Boston Edison

May 14, 1997
BECO Ltr. 2.97.035

**Response to Request for Additional Information
Concerning Pilgrim Station Crediting Containment Overpressure
in the Net Positive Suction Head Analysis for the Emergency Core Cooling Pumps
(TAC No. M97789)**

Figure 1 - Comparison of DBA-LOCA Suppression Pool Temperature Response for Different Decay Heat Inputs

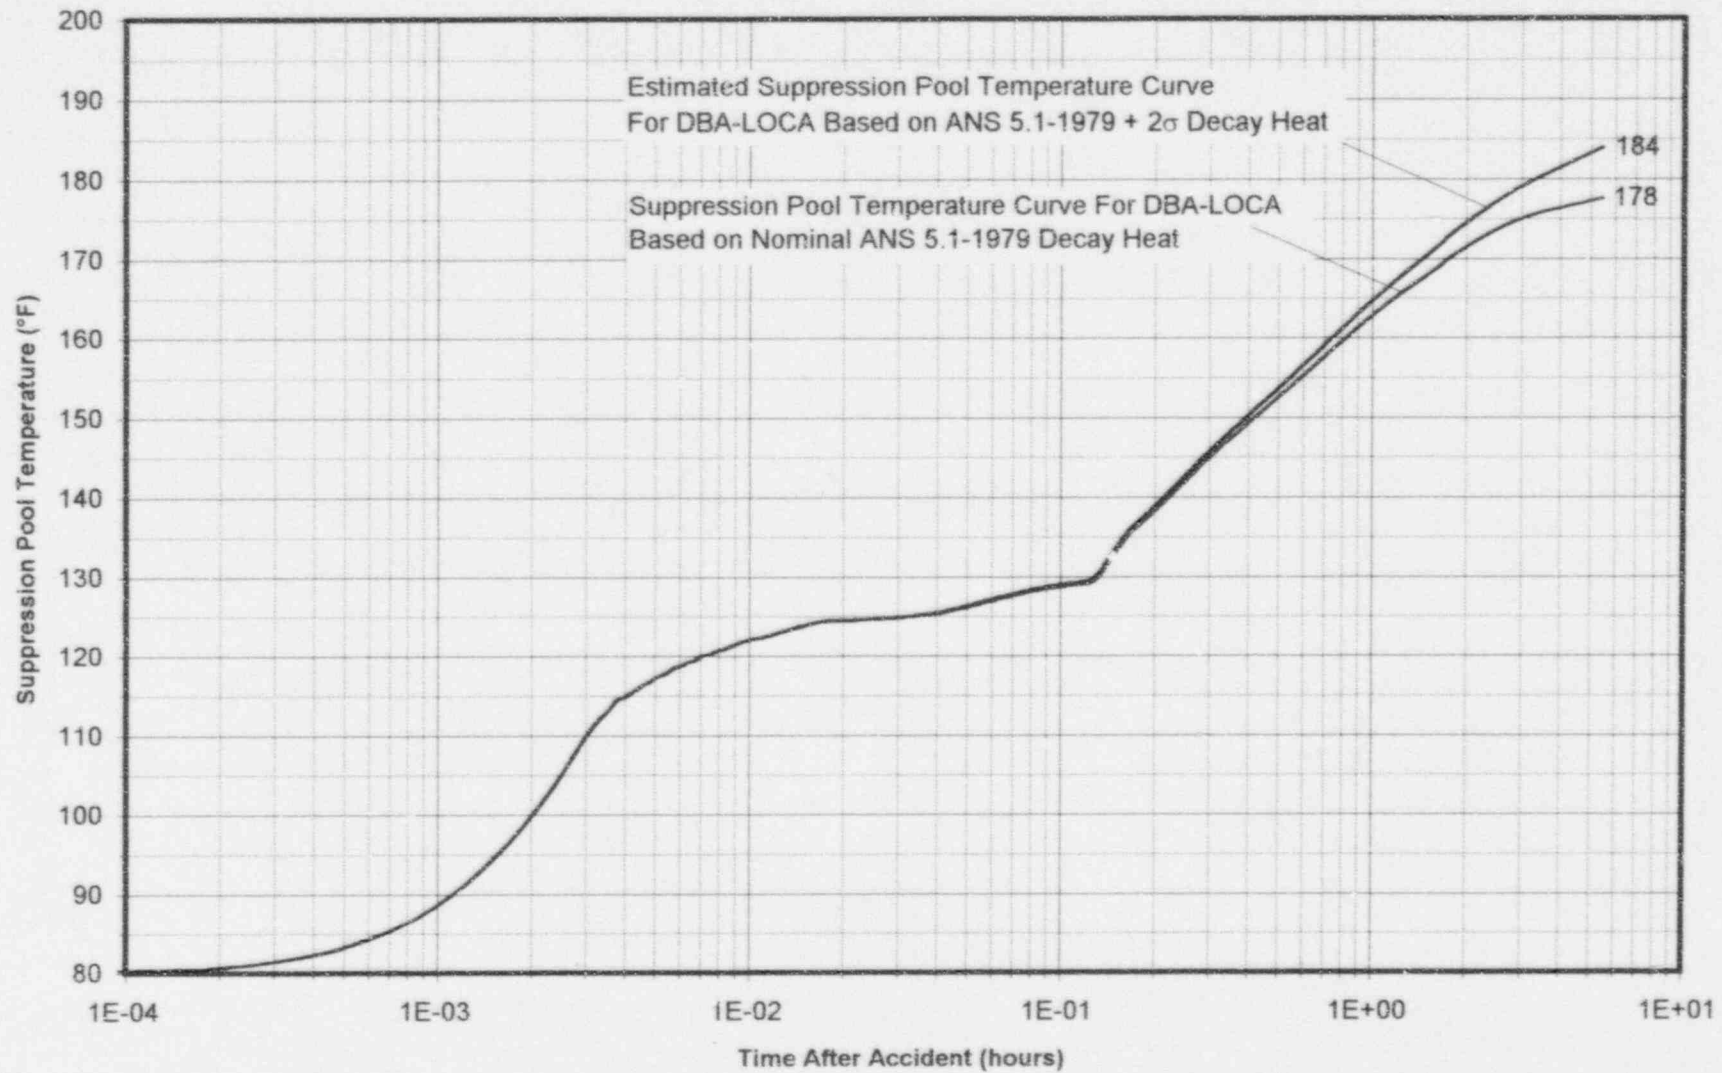
An analysis of the DBA-LOCA with 2σ uncertainty added to the decay heat will result in a more rapid containment heatup and higher peak suppression pool temperature than resulted from the analysis discussed in SE 2983 which was based on the nominal decay heat described above. The peak suppression pool temperature resulting from the DBA-LOCA with 2σ uncertainty added to the decay heat will be less than 185°F which is 7°F higher than the 178°F peak pool temperature resulting from analysis that used a nominal decay heat without uncertainty added. This estimate of 185°F was calculated by adding to the suppression pool temperature for the nominal decay heat case (i.e., 178°F) the temperature change resulting from the additional decay heat energy from the 2σ uncertainty adder. That is, the additional decay heat energy due to the 2σ adder was integrated over finite time increments and then added to the suppression pool water to increase its temperature. No accounting was made of the higher heat removal rates (due to the higher temperature across the RHR heat exchanger) that will occur between the time of containment cooling initiation and the time that the peak suppression pool temperature occurs at approximately 20,000 seconds. No accounting is made of the portion of the additional energy that will be stored elsewhere inside the containment, to be removed later in the cooldown. All of the additional energy from the 2σ uncertainty adder between 0 to 20,000 seconds is assumed to be present in the suppression pool at 20,000 seconds, thereby, raising the suppression pool temperature to a conservative estimated maximum of 185°F. Figure 1 illustrates the pool temperature response calculated using the method described above.

Figure 2 - Comparison of Requested Pressure to Containment Pressure Available and Containment Pressure Required

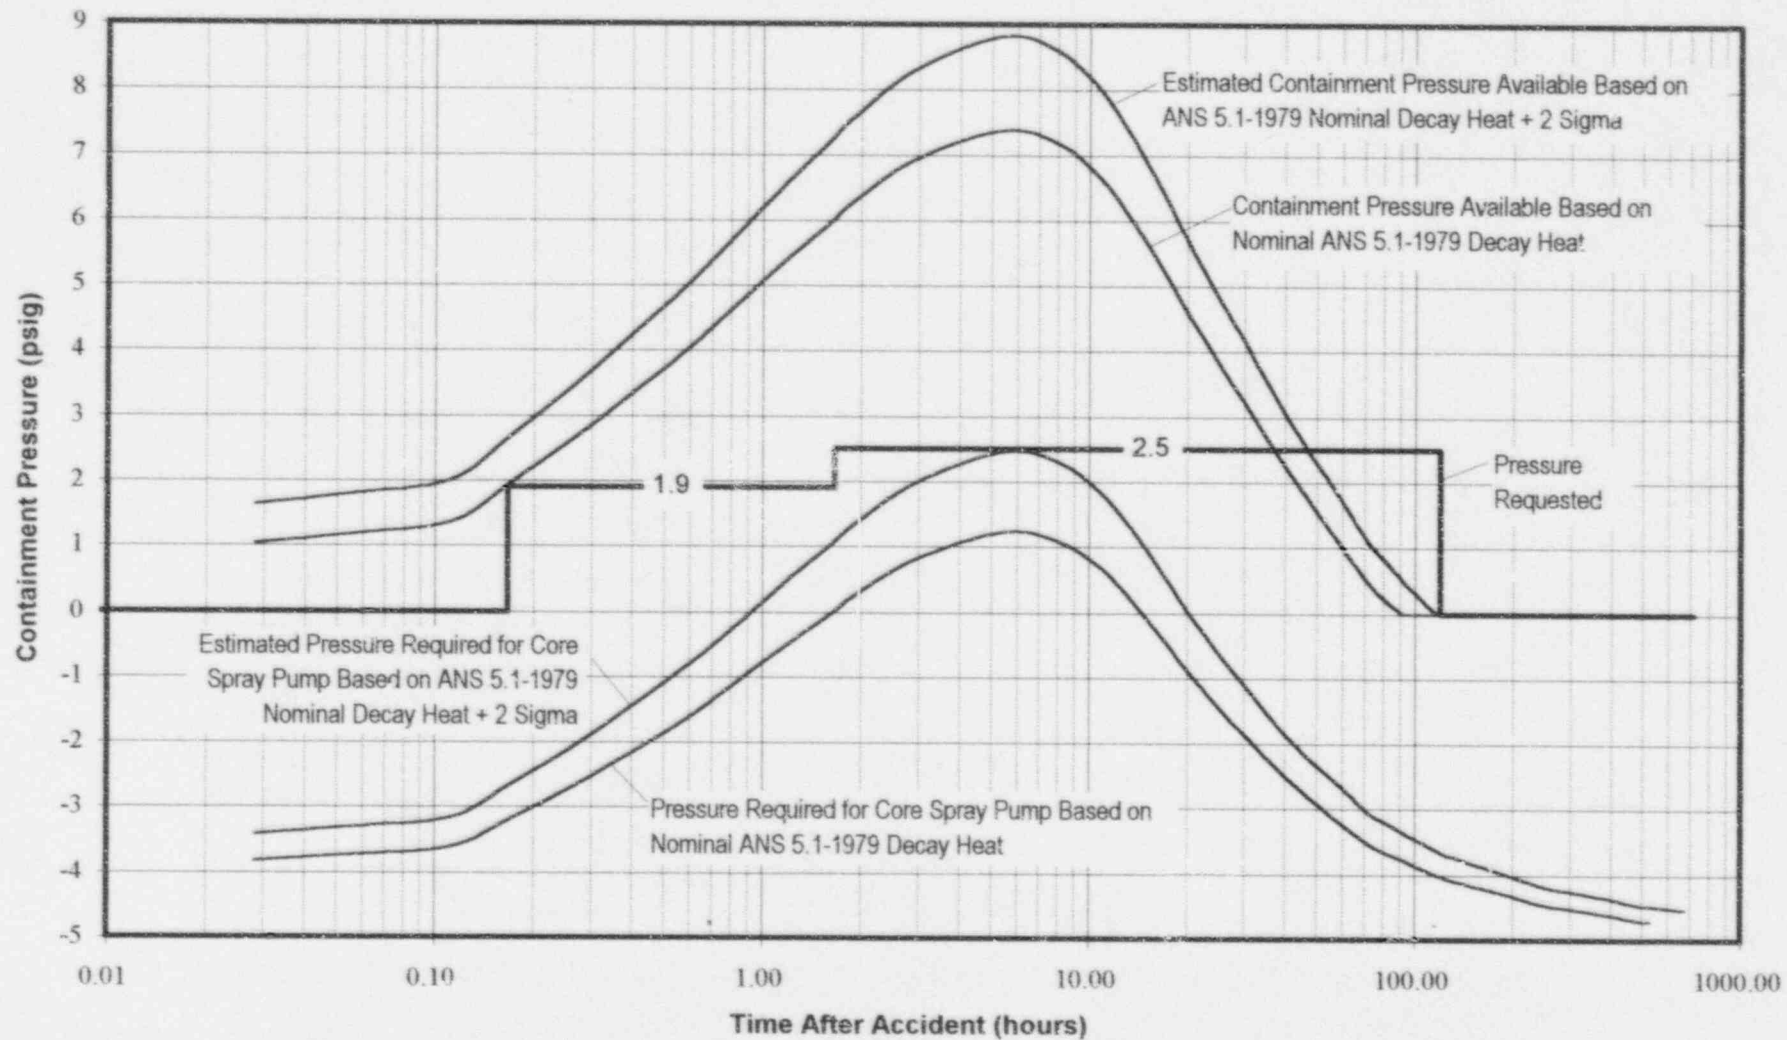
Figure 2 in this response, compares the requested values of containment pressure as a function of time against the containment pressure available assuming 5% leakage of noncondensable gas as illustrated on FSAR Figure 14.5-18. Also included on this figure is pressure required for the limiting ECCS pump(s) which is the core spray pump. However, the pressure required curve for the core spray pump is slightly higher than that shown on FSAR Figure 14.5-18 because the suction line loss was increased by 2 feet to accommodate IST measurement variations, and the pressure required to compensate for debris related head loss of .01 feet was included. As the figure illustrates, the pressure requested is less than that which will be available and greater than that which will be required.

Also included on Figure 2 is the estimated containment pressure available based on the ANS 5.1-1979 decay heat plus a 2 sigma uncertainty adder. The peak pressure available corresponds to the peak suppression pool temperature discussed previously in this response of 185°F. The estimated peak pressure required of 2.46 psig also corresponds with the estimated peak suppression pool temperature of 185°F.

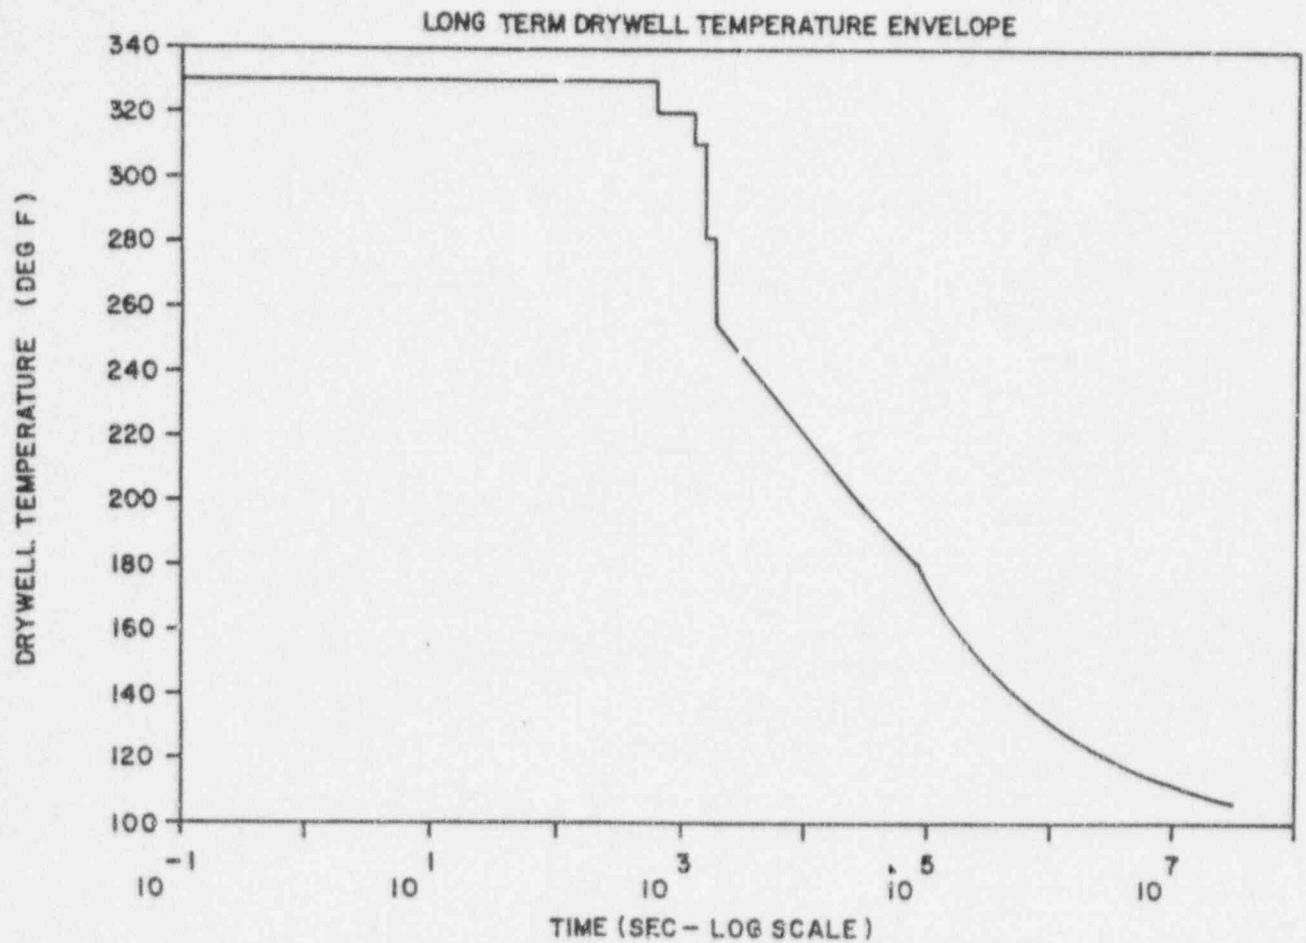
Wyle Report No. 47066-PEN-1.1, Qualification Verification Report on General Electric Electrical Penetrations No. 238X600NLG1 for use in Pilgrim 1 Nuclear Power Station, Revision F, dated March 20, 1996 indicates that exposure of the penetration epoxy to radiation will cause weight loss (i.e., aging). From information presented in the EQ documentation package, it is not clear how aging due to radiation effects has been addressed and combined with aging due to thermal effects to demonstrate qualification of the penetration. Provide clarification.

The impact of radiation aging on the penetration epoxy was addressed in Wyle Report 47066-PEN-1.1 Rev. F. Some loss of life (< 25%) due to radiation was thought to be acceptable based on the relative insensitivity of the epoxy to the drywell temperature (424 years at 150°F). Once it was identified the activation energy used to calculate expected life of the epoxy in Rev.

Since that time, Revision G of Wyle report 47066-PEN-1.1 was issued. This revision of the penetration qualification report provides a more detailed evaluation of the impact of radiation on the penetration epoxy. Specifically the report takes credit for a sacrificial layer of epoxy that reduces the impact of Beta to a negligible level in the area of the penetration seals. The remaining radiation, $2.85E7$ Rads gamma, is below the damage threshold level of $1E8$ Rads established via General Electric testing. Based on this evaluation, it has been determined that it is not necessary to reduce the expected life of the penetration epoxy due to the affects of radiation.
